**Title: Stage 1&2 ROAD SAFETY AUDIT**

**Proposed Large Scale Residential Development (LRD) at  
Oldcourt LAP Lands, Oldcourt Ballycullen/Bohernabreena Co.  
Dublin.**

**Report reference: 2291R01**

**VERSION: FINAL (13-8-2024)**

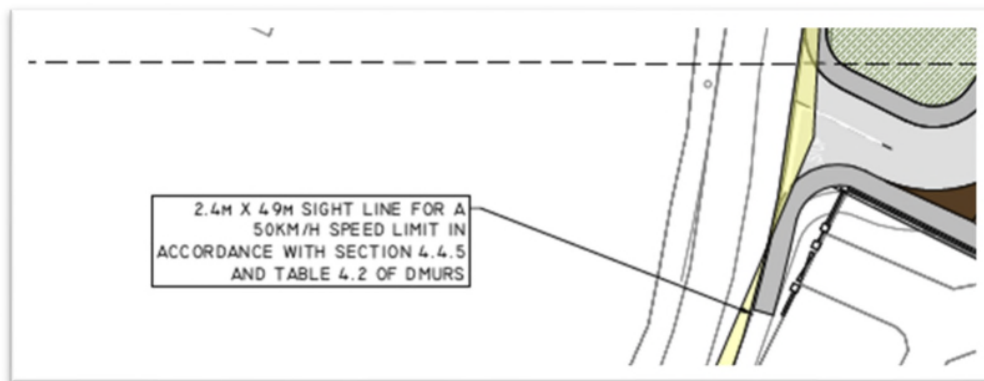
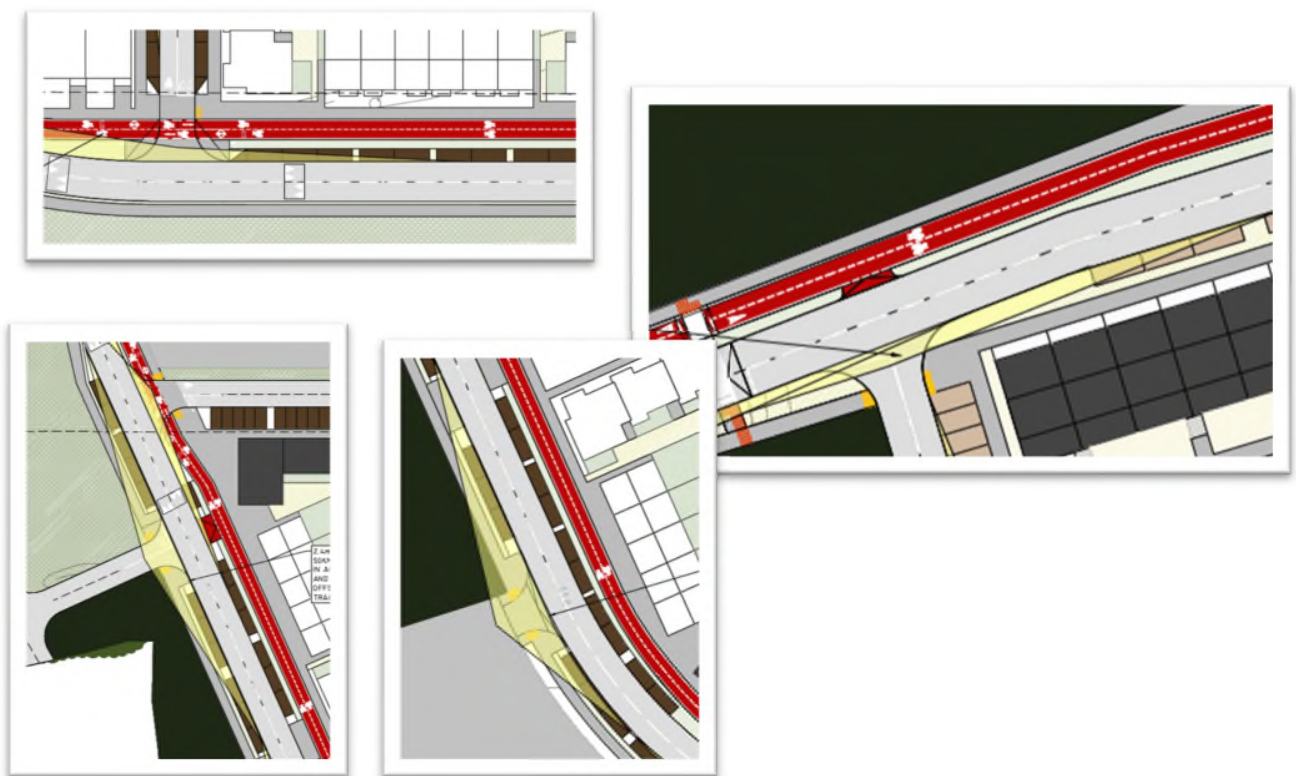
Bohernabreena Road.

The sightlines shown on the drawings assume a speed limit of 50km/hr on Bohernabreena Road. The existing speed limit is 60km/hr. A lack of suitable visibility could lead to side-impact or rear-end collisions.

Minimum Visibility Distance to Signal Heads	
85% Approach Speed KM/H	Minimum Visibility Distance
40 KM/H	40m
50 KM/H	70m
60 KM/H	90m
80 KM/H	145m
Separation Distance to Junction:	
	20m

It is recommended that sightlines be provided in accordance with the speed limit on Bohernabreena Road.

Paragraph No. in Safety Audit Report	Problem accepted (yes/no)	Recommended measure accepted (yes/no)	Alternative measures (describe)	Alternative measures accepted by Auditors (Yes/No)
3.1	Yes	Yes		
3.2	Yes	Yes		
3.3	Yes	Yes		
3.4	Yes	Yes		
3.5	Yes	Yes		
3.6	Yes	Yes		
3.7	Yes	Yes		
3.8	Yes	Yes		
3.9	No	No	Layout based on Reg. Ref. SD17A/004 which was permitted by SDCC.	Yes
3.10	Yes	Yes		
3.11	Yes	Yes

Drawings P211102-PIN-XX-DR-D-110 & 111-SI P02, Sightlines at priority junctions onto Spine Road.

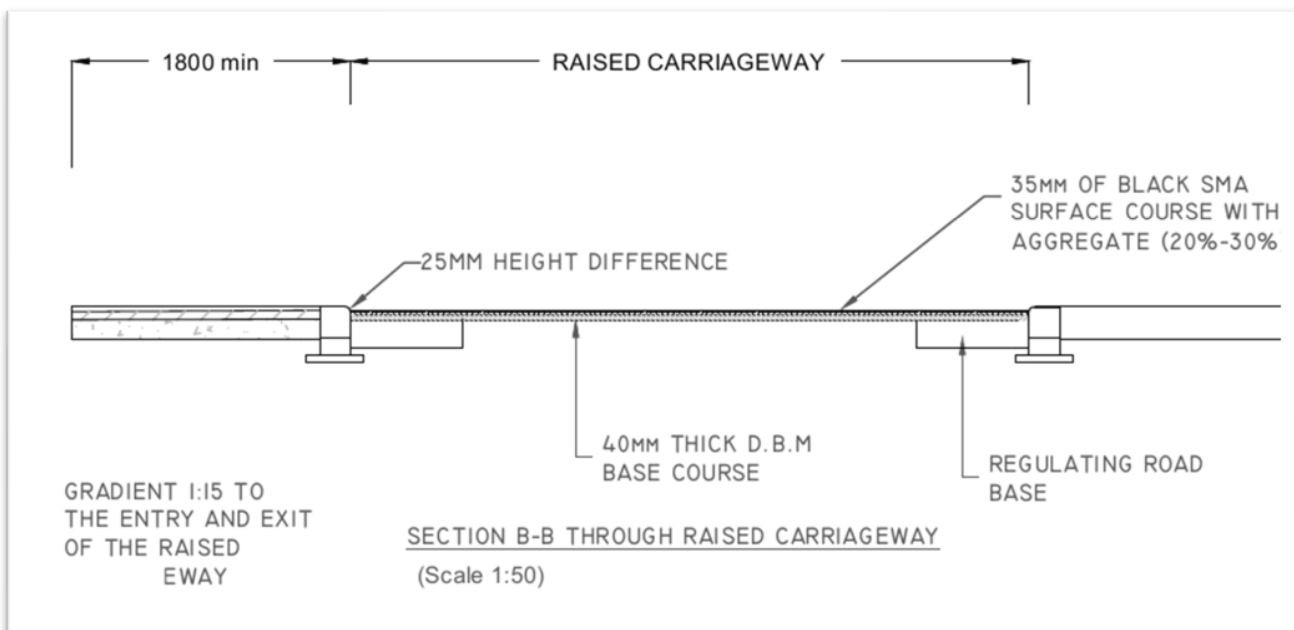
The visibility to the left and/or right for drivers entering onto the Link Road from some internal roads cut through a number (up to 5 no. spaces) of parallel car parking spaces. If these spaces are occupied, especially by a van or similar vehicle then the visibility will not be achieved. This could lead to side-impact or rear-end collisions.

It is recommended that the layout of the parallel parking be modified to achieve the required sightlines.

Drawing PIN-ZZ-XX-DR-D-142-SI P01, At Grade Crossing layout.

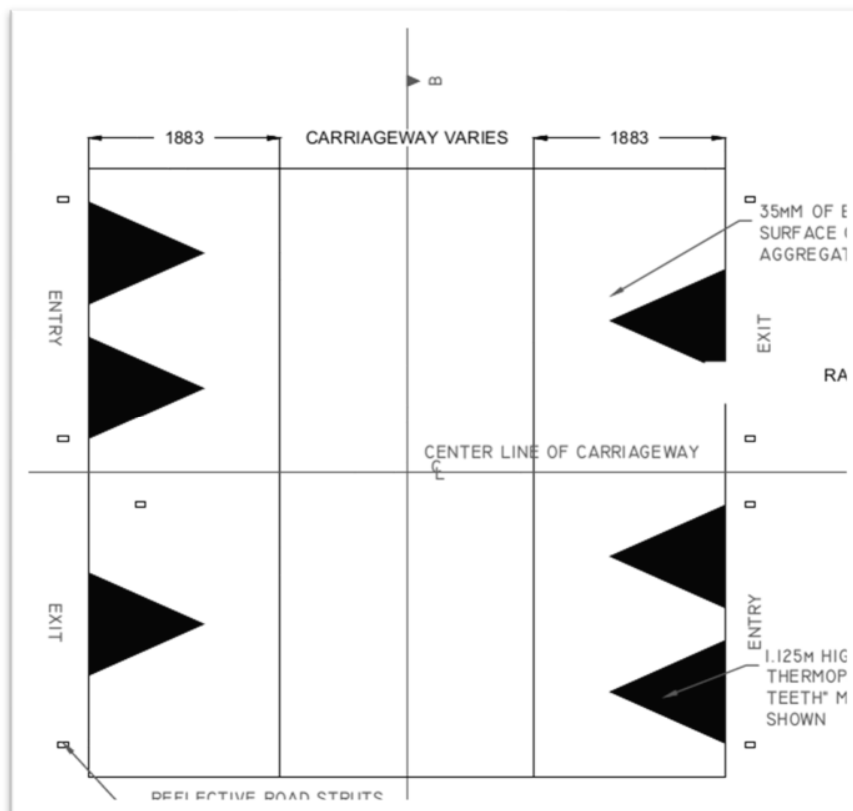
Section B-B of the at grade crossing layout shows a 25mm kerb upstand. This may lead to trips and falls or inaccessibility for some mobility impaired users.

It is recommended that a flush kerb be provided at the crossing points.

Drawing PIN-ZZ-XX-DR-D-142-SI P01, At Grade Crossing layout.

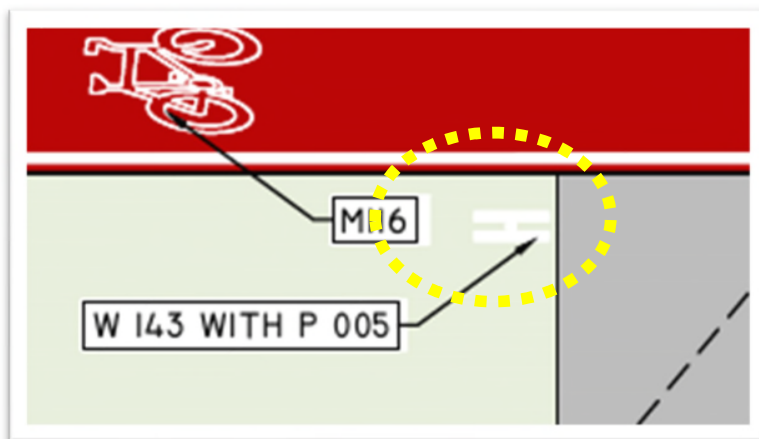
The at grade crossings extend from kerb to kerb. There is a risk of surface water ponding at the start of the upstream ramp which could lead to loss of traction and loss of control.

It is recommended that gullies be provided upstream of such crossings/raised tables.

Drawing PIN-ZZ-XX-DR-D-142-SI P01, W143 Sign with P005 supplementary plates.

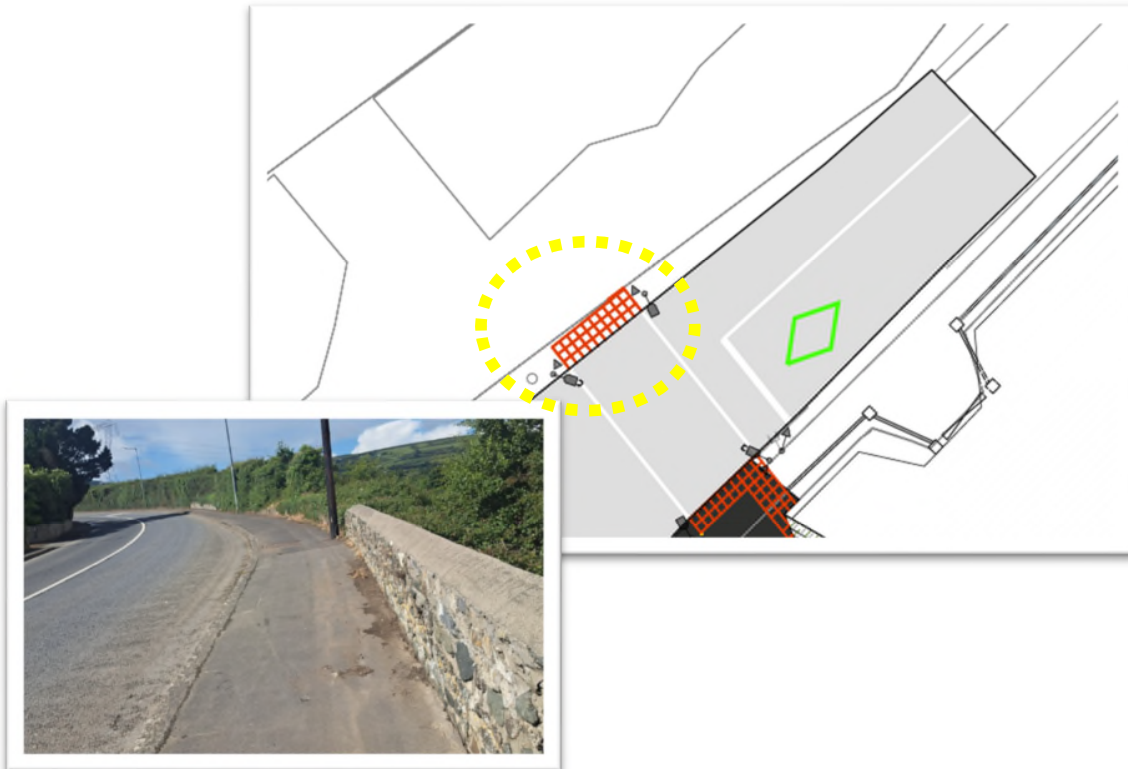
It is unclear if back to back W143 signs with P005 supplementary plates are proposed. For drivers exiting the side roads the warning signs may be ineffective when located after the hazard which could result in inappropriate approach speeds to the hazard.

It is recommended that advance warning signs be provided a suitable distance in advance of the hazard.

Drawing P211102-PIN-XX-DR-D-150 SI P02, Bohernabreena Road Toucan crossings.

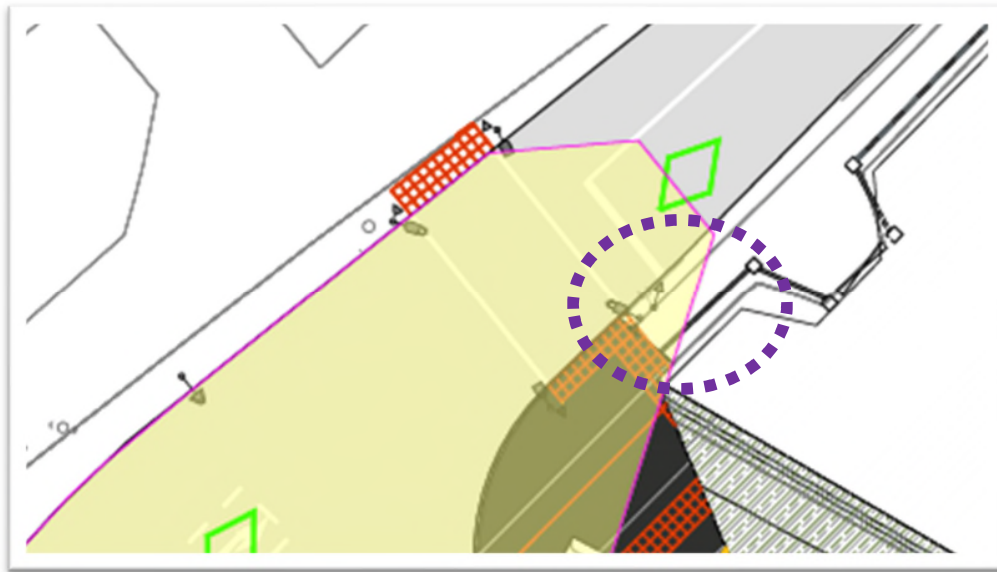
There are two toucan crossings proposed on Bohernabreena Road however there are no areas for cyclists to transition from on-road to off-road except at the crossing. This could lead to cyclists travelling for longer distances on the footpath thereby putting pedestrians at risk or to cyclists mounting/dismounting the high kerbs resulting in loss of control.

It is recommended that a suitable dropped kerb be provided to allow cyclists access to the toucan crossing areas.

Drawing P211102-PIN-XX-DR-D-150 SI P02, Bohernabreena Road, Junction intervisibility.

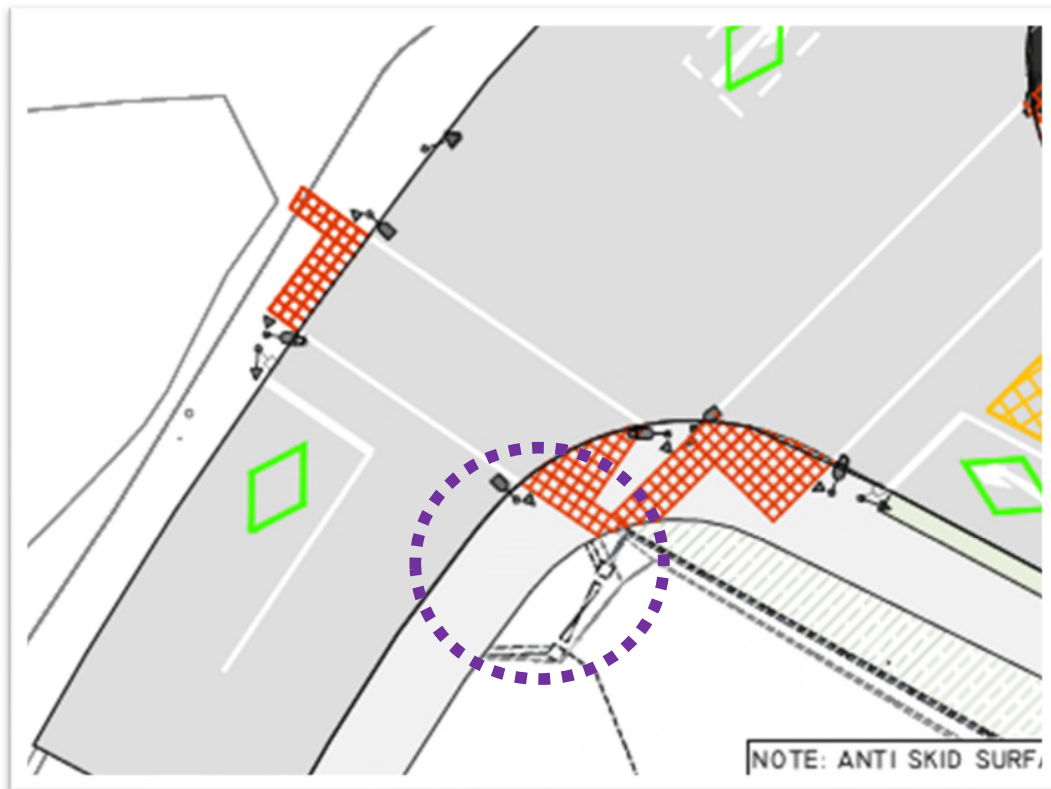
The intervisibility line cuts through the boundary wall of the neighbouring property on the northern side of the Bohernabreena Road junction. This wall may be too high to allow visibility which could result in collisions.

It is recommended that suitable intervisibility be provided in both the horizontal and vertical planes.

Drawing P211102-PIN-XX-DR-D-161 SI P02, Typical uncontrolled tactile paving.

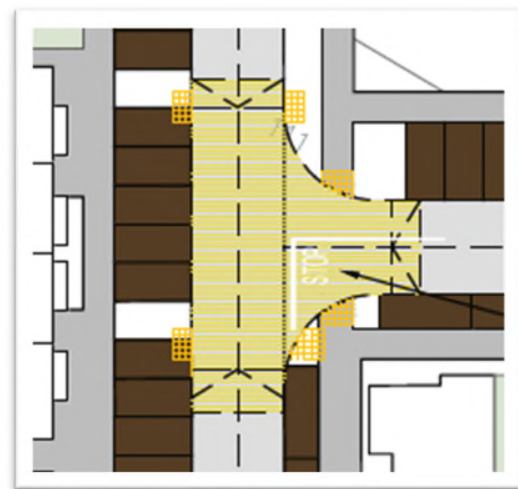
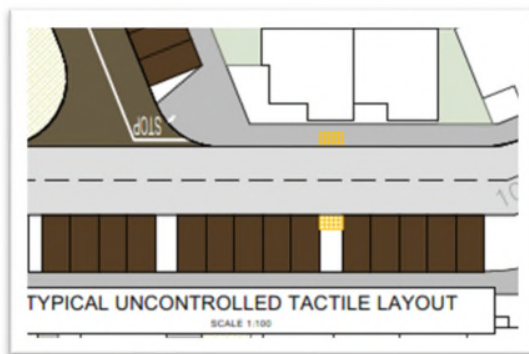
The drawing shows an uncontrolled pedestrian crossing between two perpendicular car parking spaces. A child could run out between two parked vehicles and a driver would not have time to react given the limited intervisibility.

It is recommended that suitable visibility be provided at uncontrolled pedestrian crossings throughout the scheme.

Drawing P211102-PIN-XX-DR-D-101-104 SI P02, Uncontrolled pedestrian crossing locations.

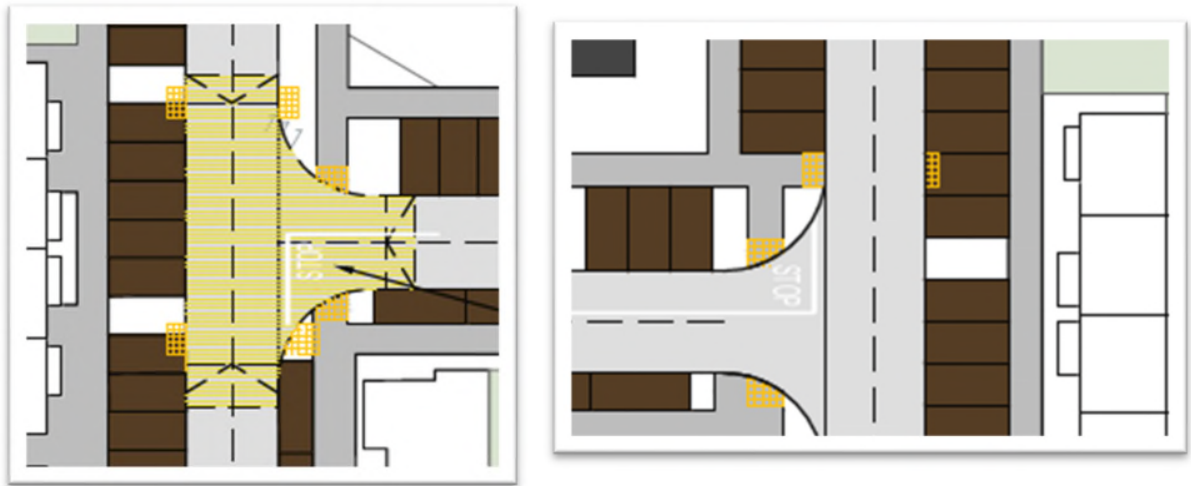
Some uncontrolled crossings are shown to coincide with parking spaces. This could lead to collisions between reversing vehicles and pedestrians.

It is recommended that uncontrolled crossings lead to footpaths only.
